| ROADWAY PLAN                                                         |                                                    |
| INTERSTATE ROUTE H-1 RESURFACING                                     |                                                    |
| Miller Pedestrian Overpass to Kapiolani Interchange                  |                                                    |
| Federal-Aid Project No. NH-HI-1(279)                                 |                                                    |

| SHEET No. R1 OF 41 SHEETS                                            |                                                    |

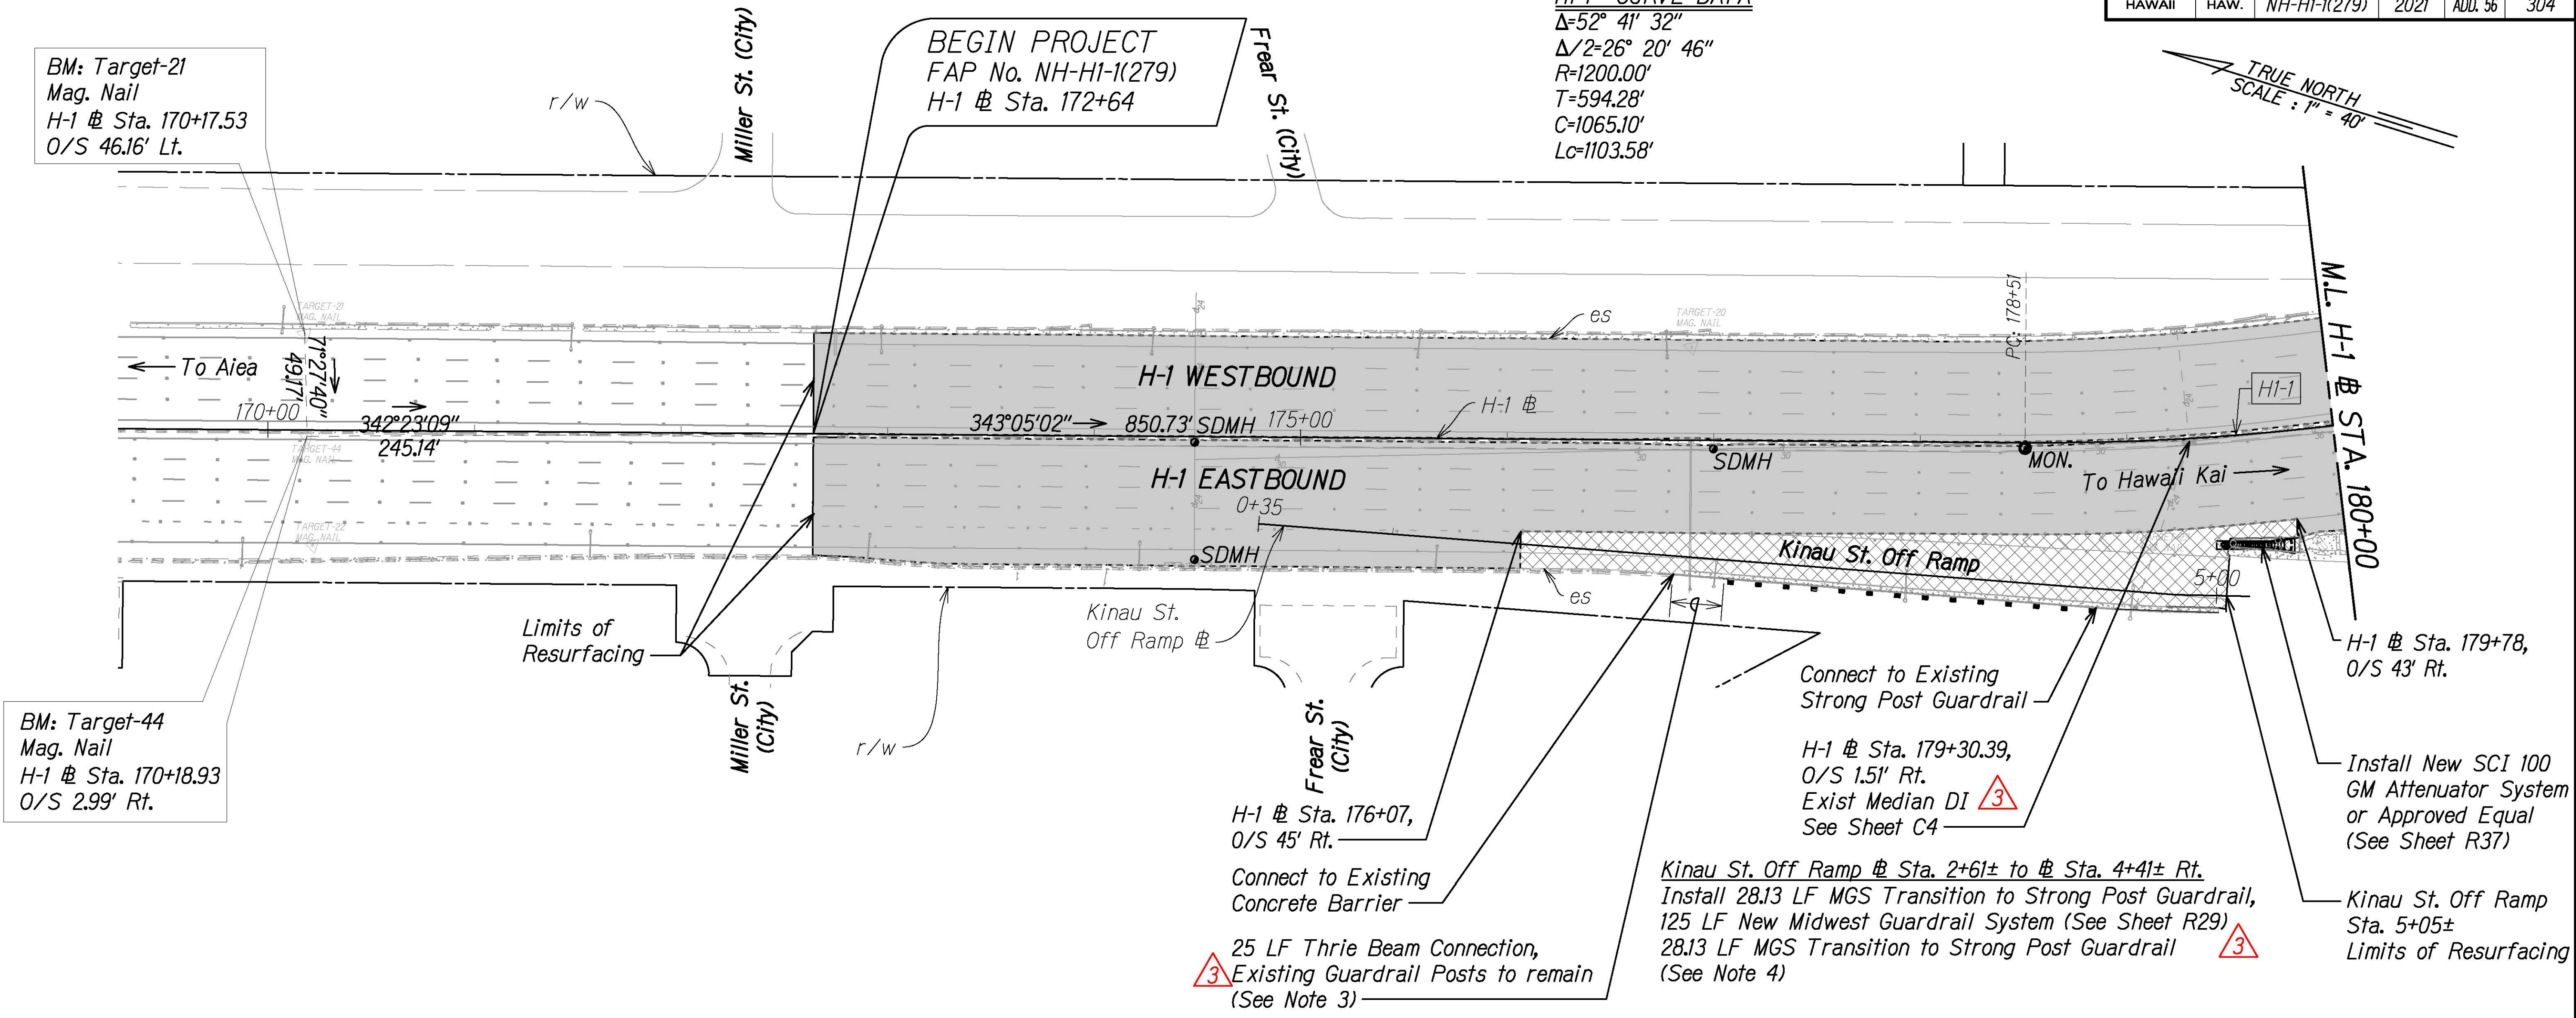
| 7/9/21                                                               | 3 Revised Guardrails, Added Exist. Median DI label |

| SHEET No. R2 OF 41 SHEETS                                            |                                                     |

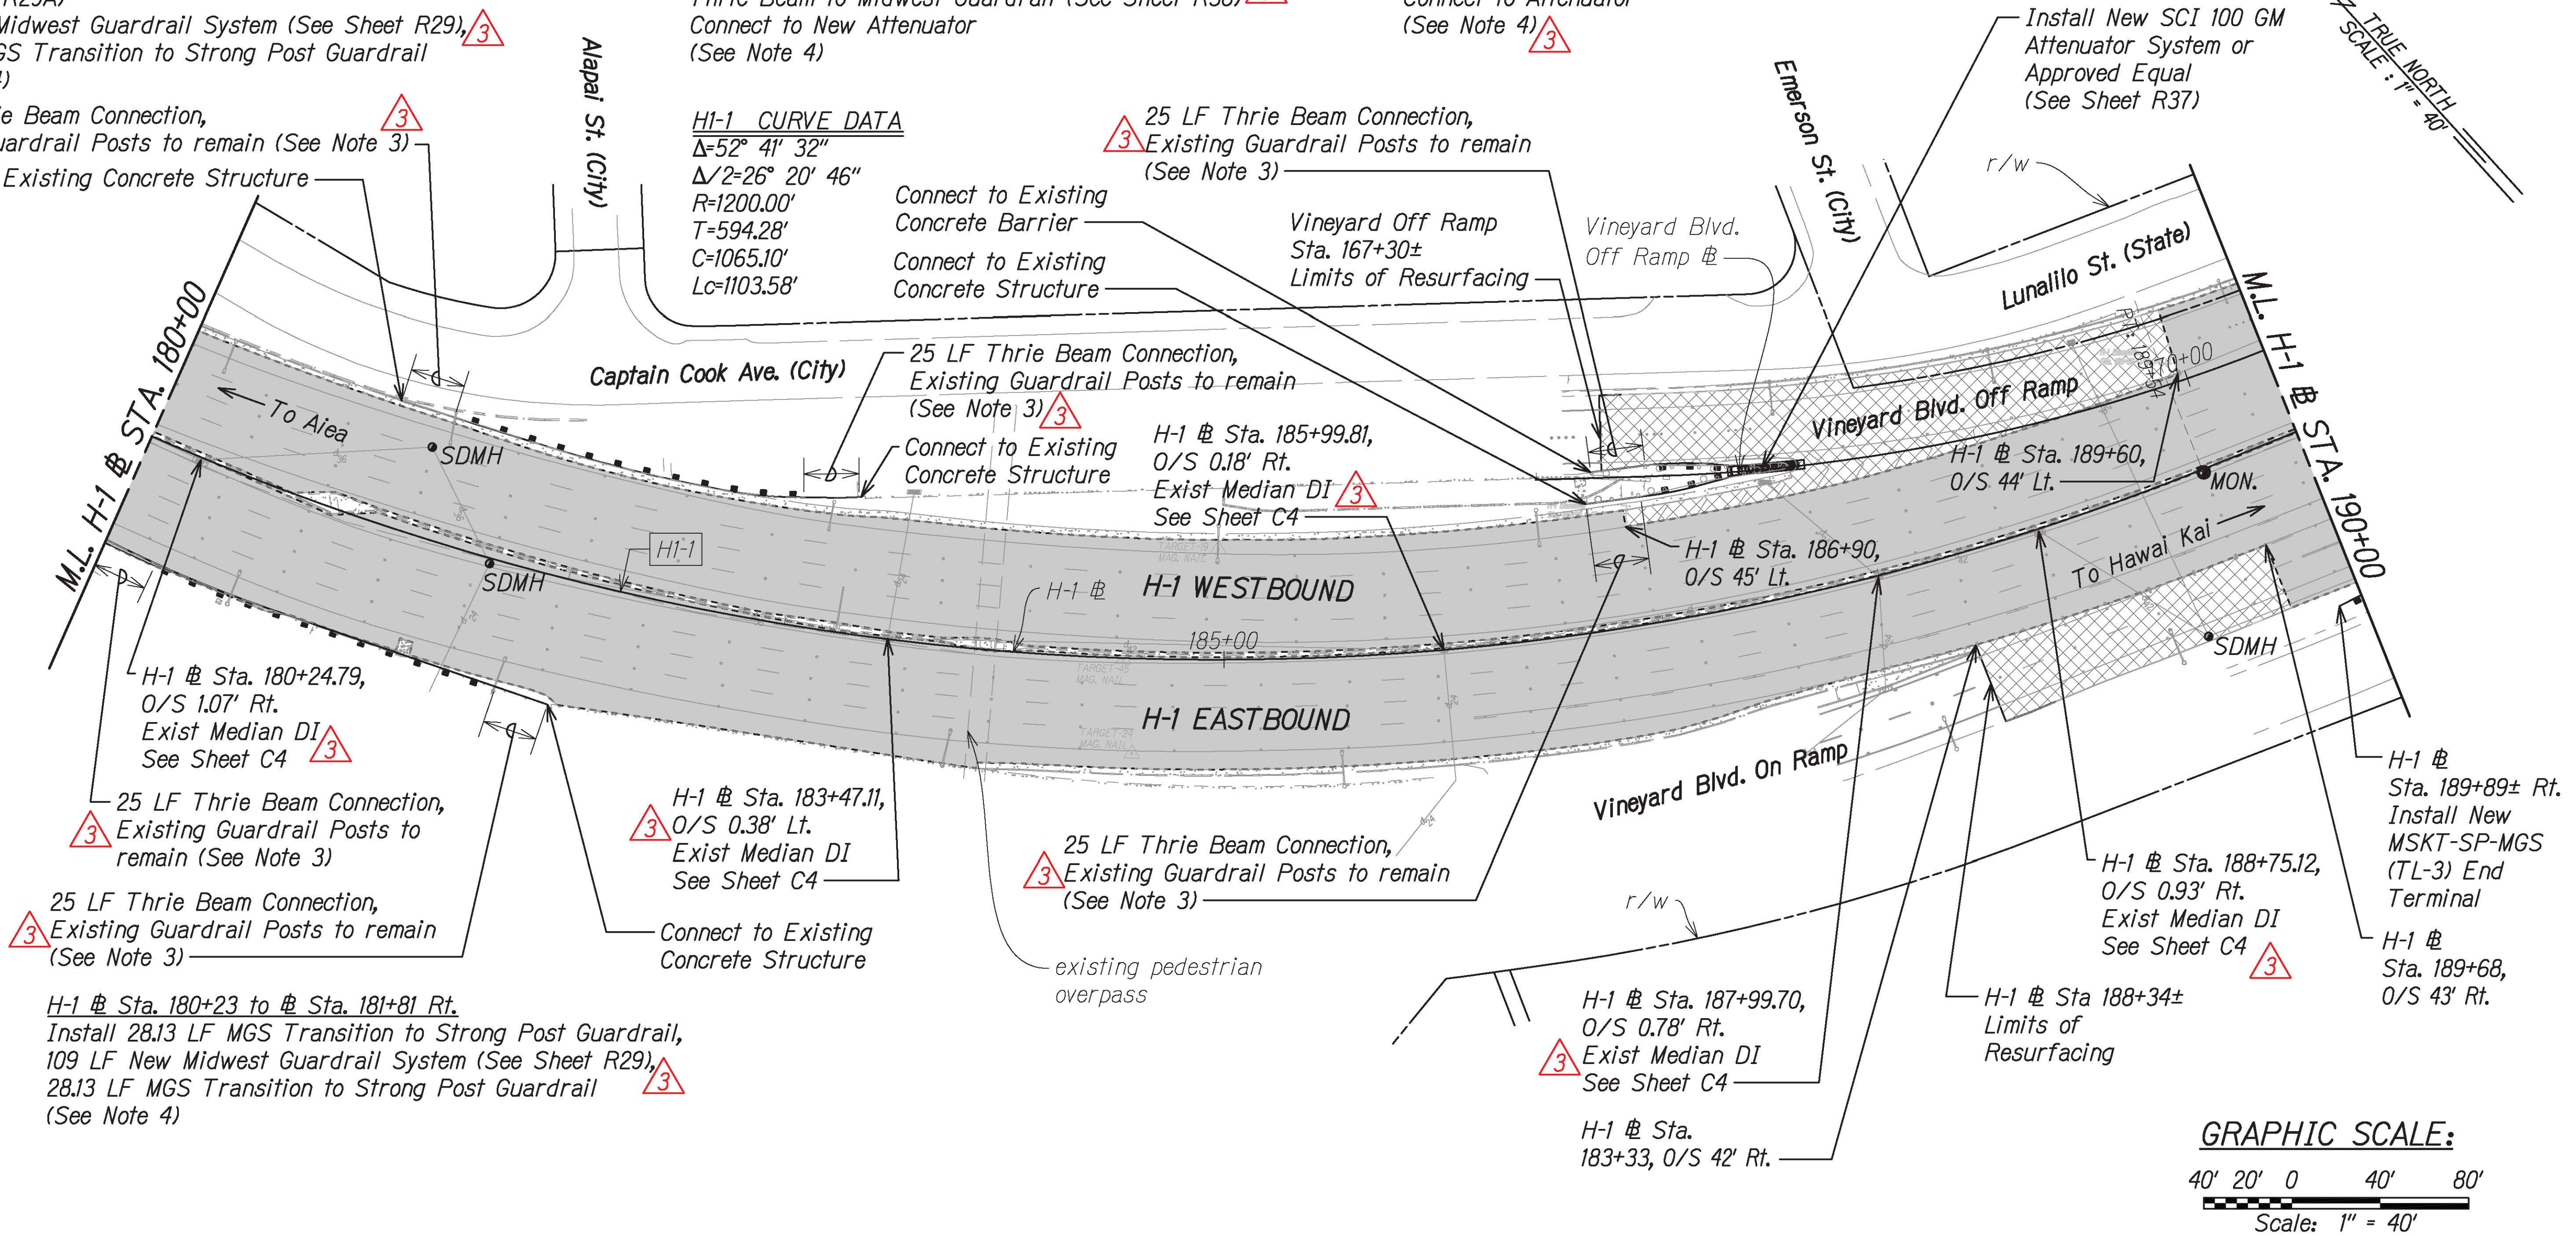
| 7/9/21                                                               | Revised Guardrails,<br>Added Exist. Median DI label |

| SHEET No. R3 OF 41 SHEETS                                            |                                                                       |

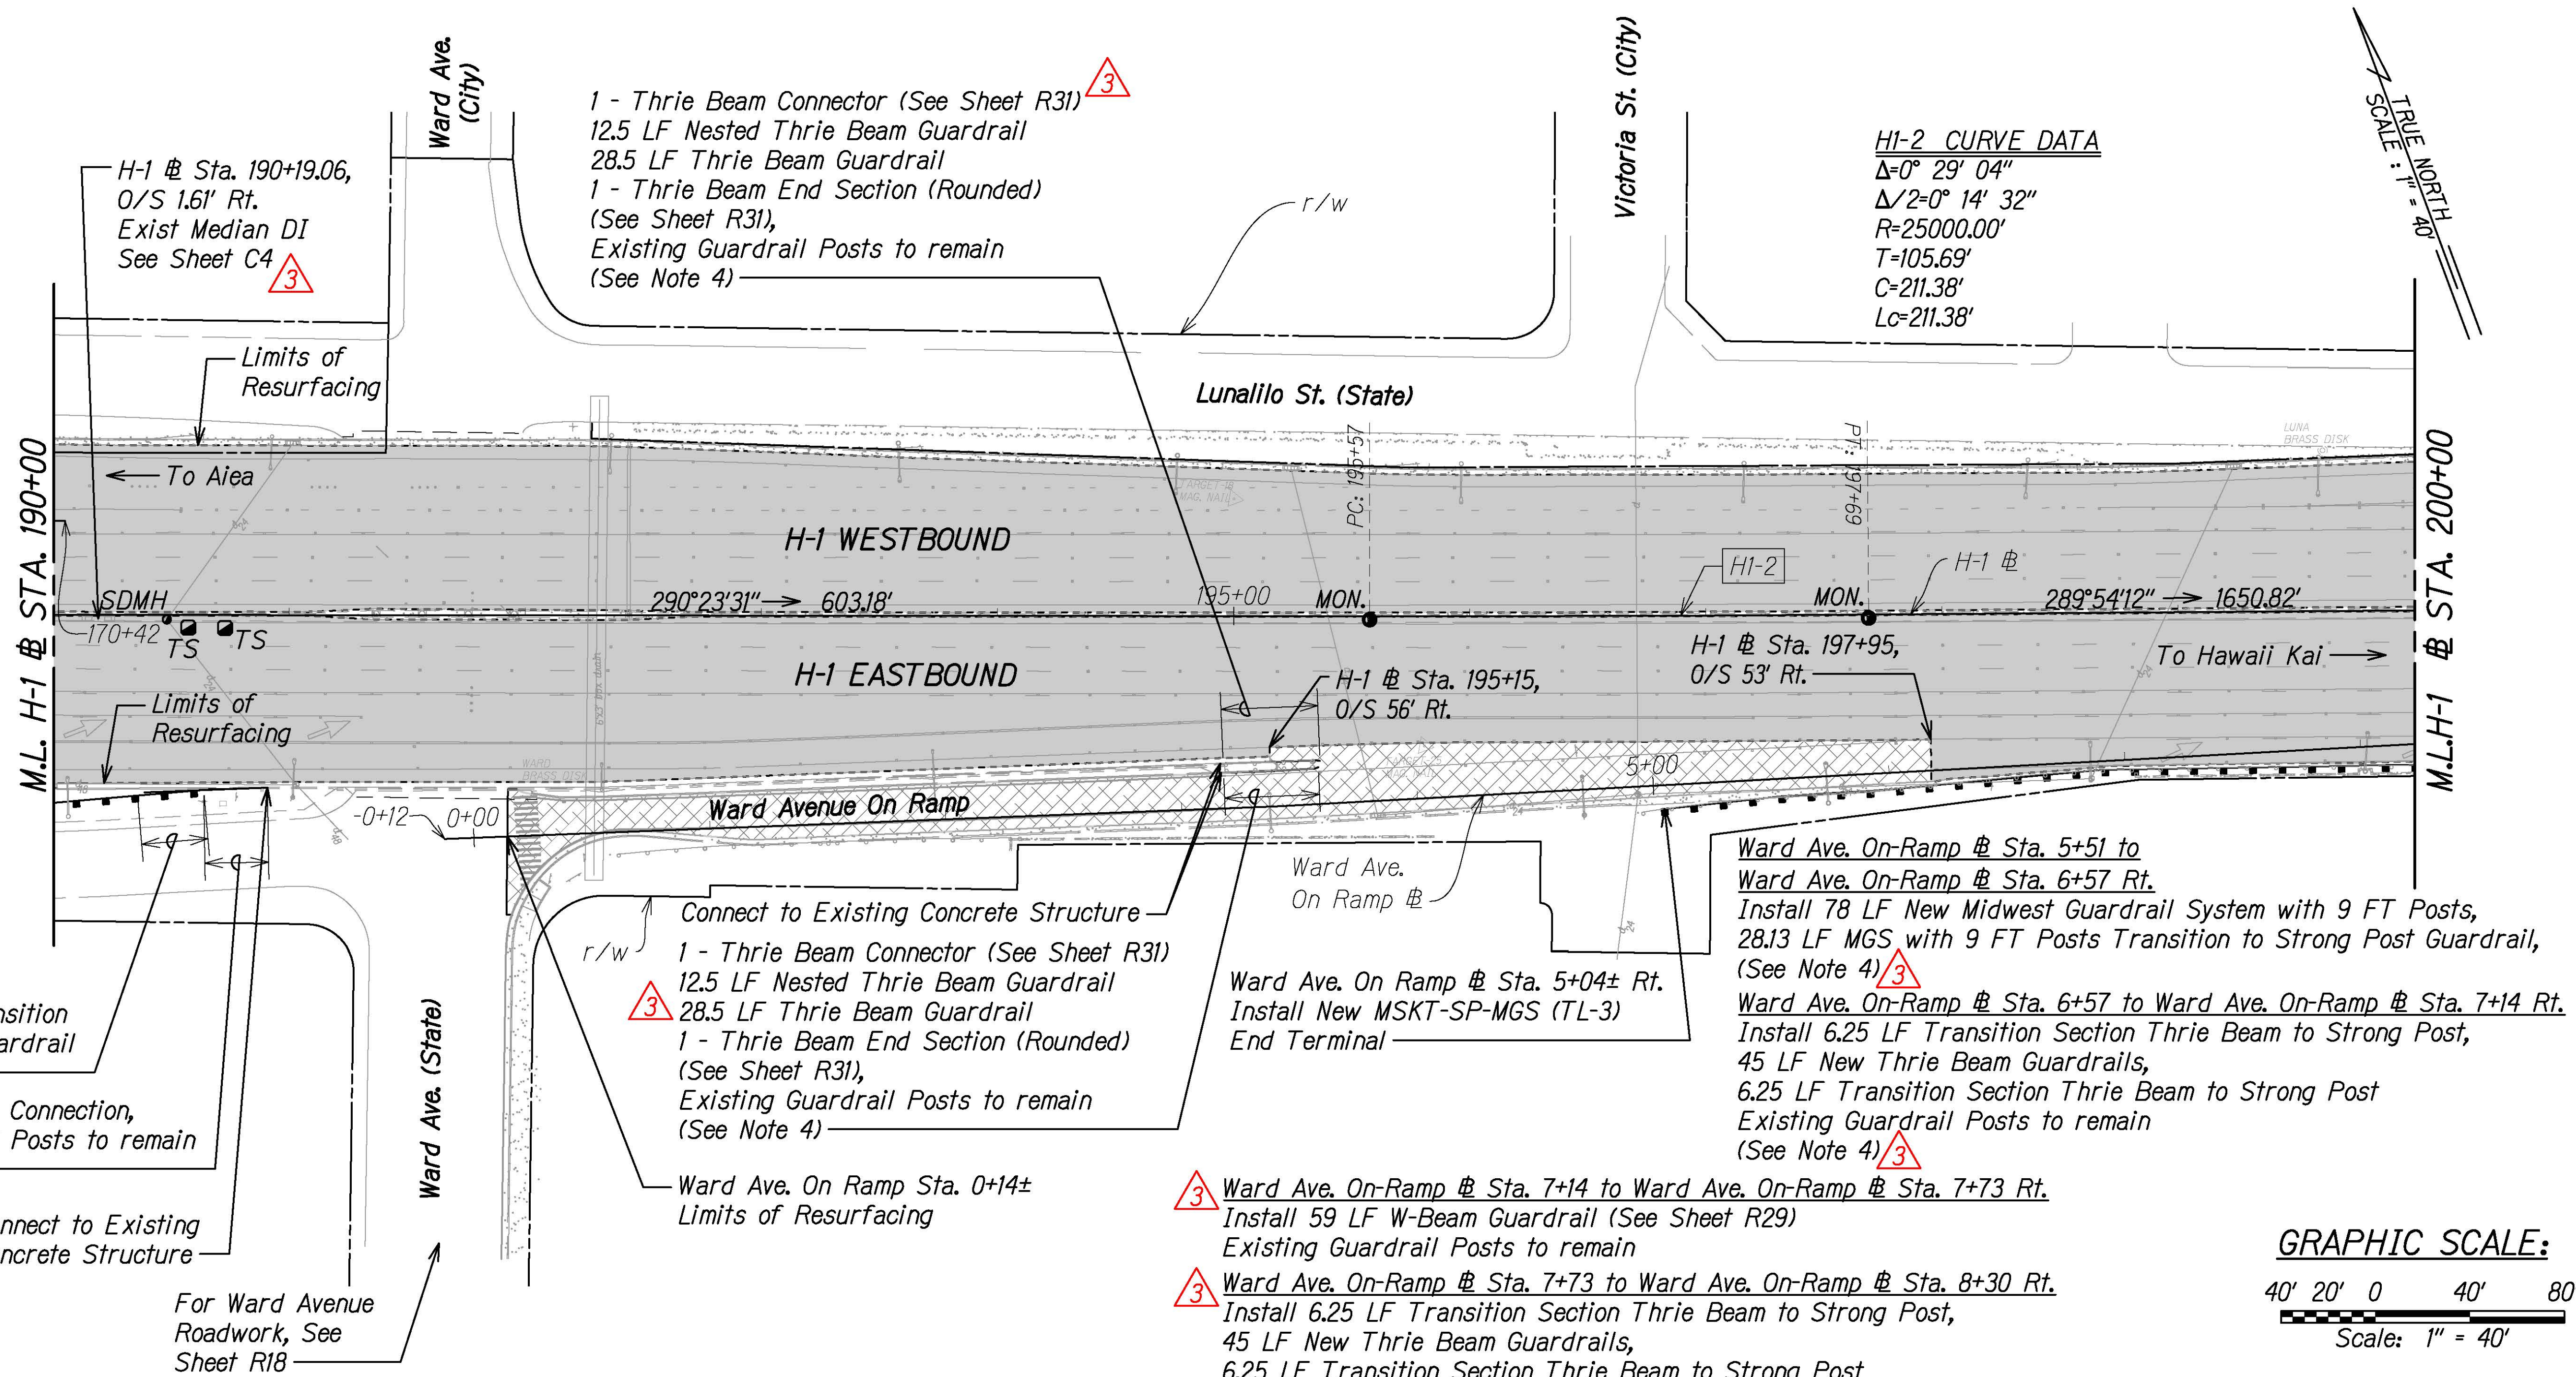
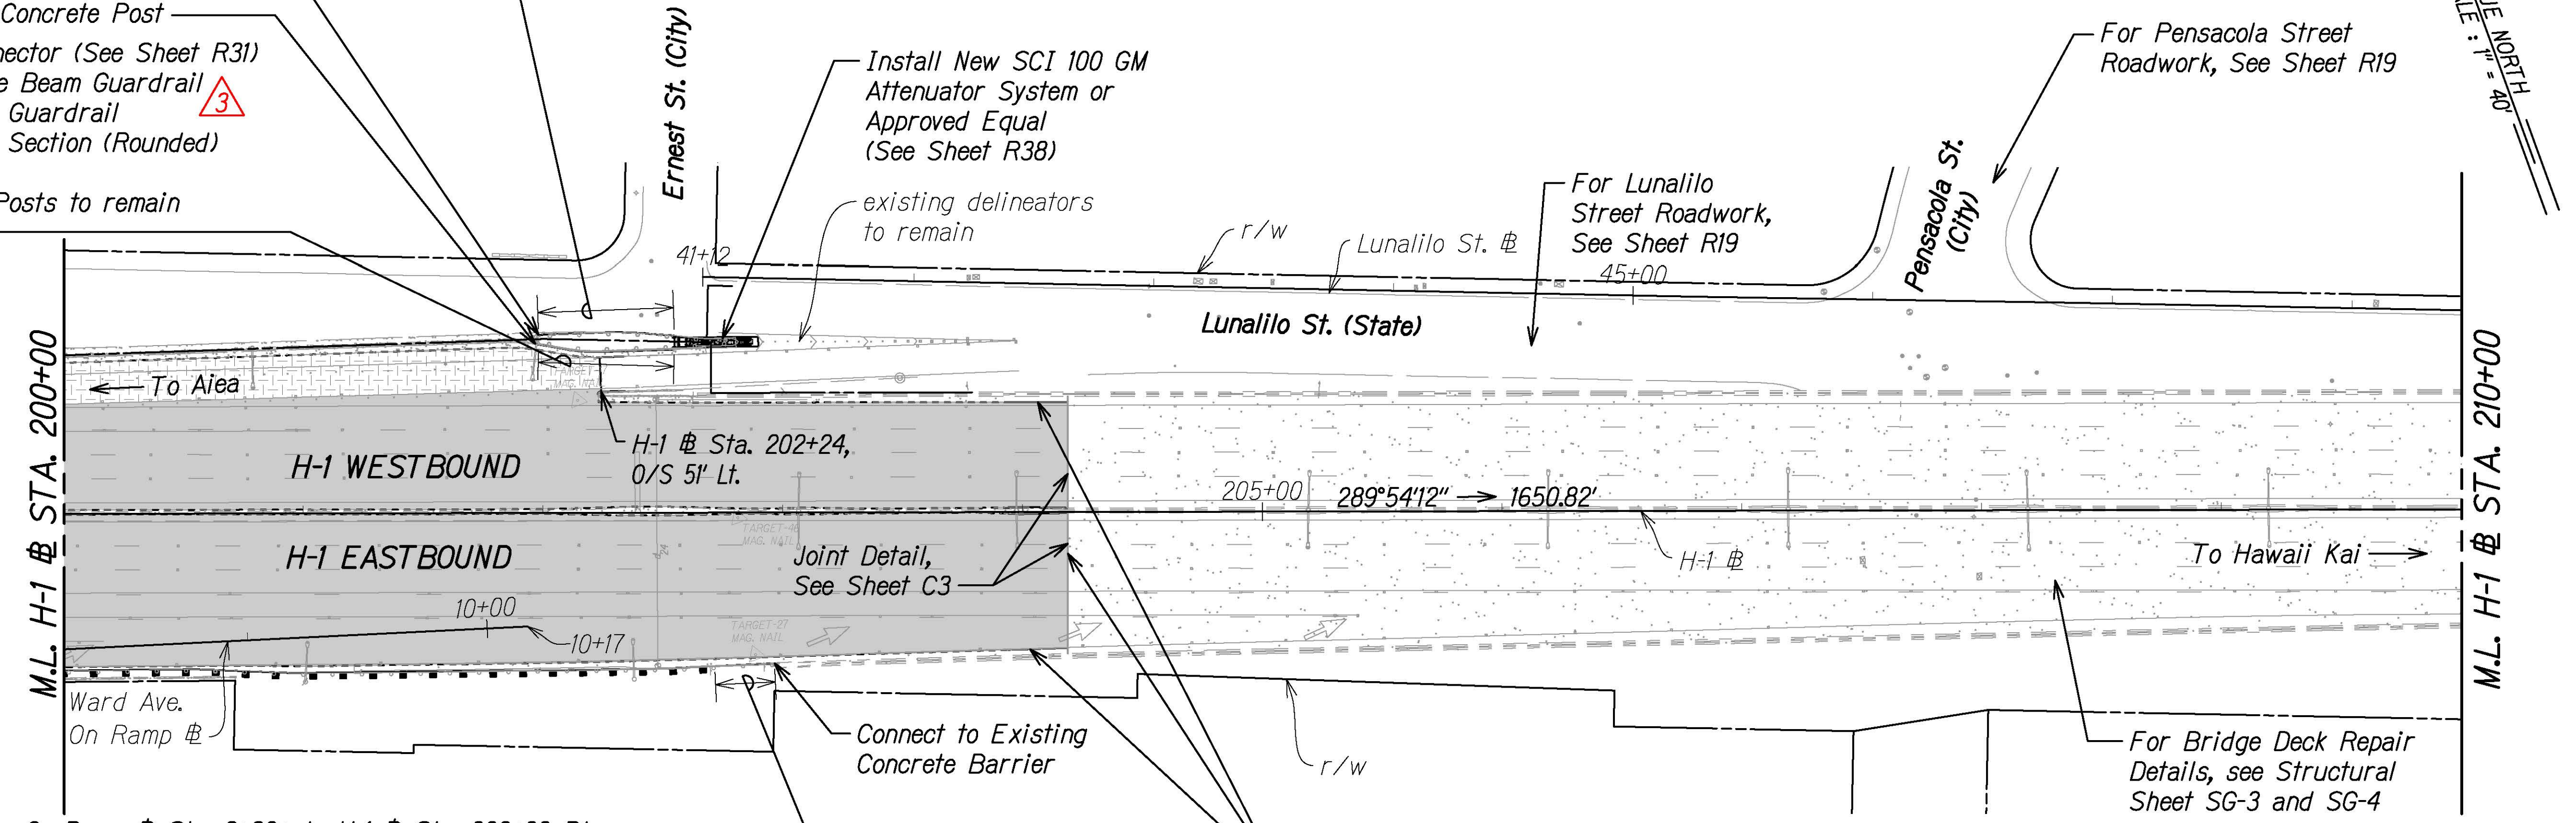
| 7/9/21                                                               | Revised Guardrails and Pavement Section, Added Exist. Median DI label |
